NCPC File No. Z.C. 03-12A/03-13A

ARTHUR CAPPER/CARROLLSBURG HOPE VI REDEVELOPMENT PROJECT
MODIFICATIONS TO FIRST STAGE AND CONSOLIDATED
PLANNED UNIT DEVELOPMENTS AND
SUMBISSION OF SECOND STAGE (PHASE I) PLANNED UNIT DEVELOPMENT

Delegated Action of the Executive Director

First Stage, Consolidated, and Second Stage (Phase I) PUD Boundaries

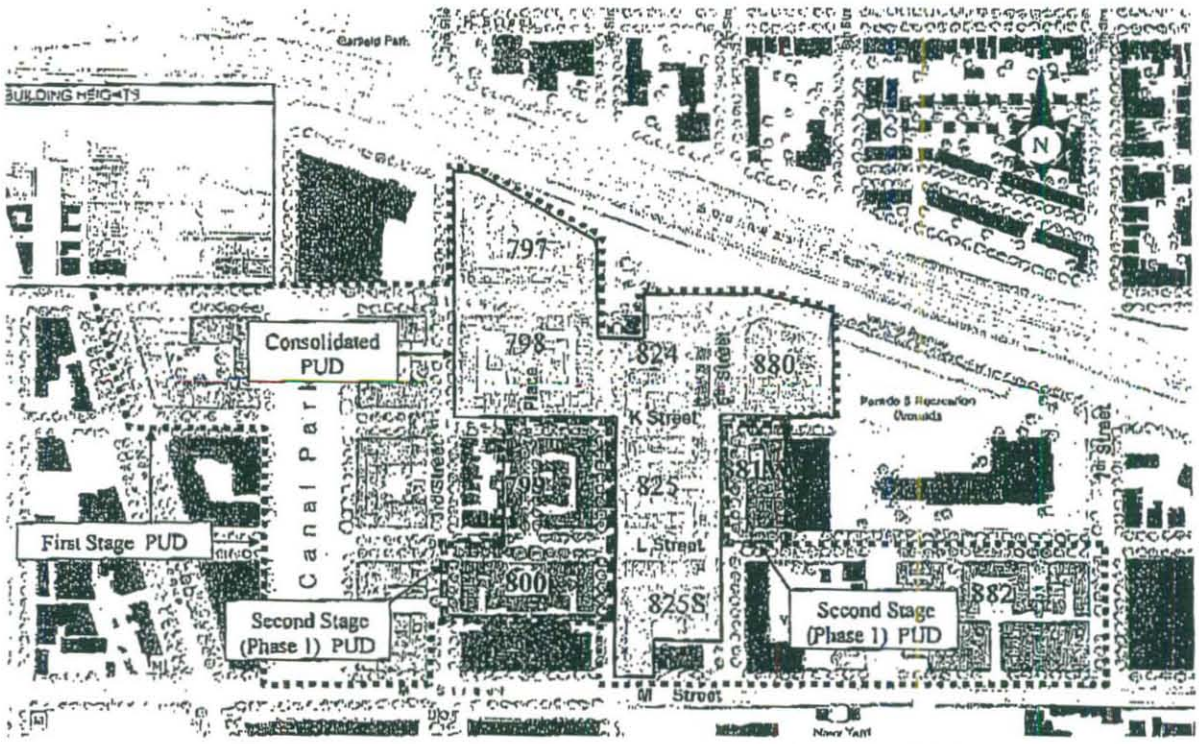
- Removing 15 of the properties in Square 799 from the Preliminary PUD, resulting in
  - Relocating proposed 3rd Place in Squares 798 and 799
    (Shifting the street's location complies with the Zoning Commission's instructions to retain as much private property as possible in Square 799 by allowing 15 additional properties to remain privately owned), and results in:
    - Increasing overall residential density from 2.21 to 2.34 FAR, and
- Reducing overall PUD parking ratio, particularly for the low-rise residential construction in Squares 825, 825S, and 882 (northern portion) from two spaces per unit to a minimum of 1.38 spaces for type A, D and E units.

- Relocating proposed 3rd Place in Square 798, and
- Reducing the PUD parking ratio within Squares 797, 798, and 824.

Requested Second Stage (Phase I) approval includes modifications to the plan approved in the First Stage PUD for Squares 799, 800 and 881 W that follow:

- Increasing the height and density of the community center in Square 881 W,
  - (Increasing the height from 25 to 35 feet would help to further screen the adjacent 56-foot high Marine Barracks garage, consistent with the design intent and importance of this building to the community).

- Constructing a roof structure for the community center that would not meet the 1:1 setback requirements of § 400.7,
  - (Increasing density to allow a future second story expansion of up to 6,600 SF, and locating a stair tower along the northern wall facing K Street, with no setback form the exterior wall would make possible a future 2nd story addition that would provide neighborhood-requested community meeting and office space).

- Changing the location and ownership status of proposed 3rd Place in Square 799.
  - (Re-designating the street's ownership would assure that it would be built to District Department of Transportation (DDOT) standards and publicly maintained, as DDOT prefers. Creation of this street would have no affect on any existing L'Enfant Street).

- Reducing the PUD parking requirements for portions of Squares 799 and 800.

In its final report dated December 9, 2005, DCOP recommended that the Zoning Commission approve the Second Stage PUD and modifications to both the previously approved PUD's, and deemed them consistent with the District elements of the Comprehensive Plan. I find that the proposal is consistent with the Comprehensive Plan for the National Capital and that it would not adversely affect any identified federal interests, and remind the District of Columbia Housing Authority that Section 5 review for both First and Second Stage PUD's remains to be submitted.
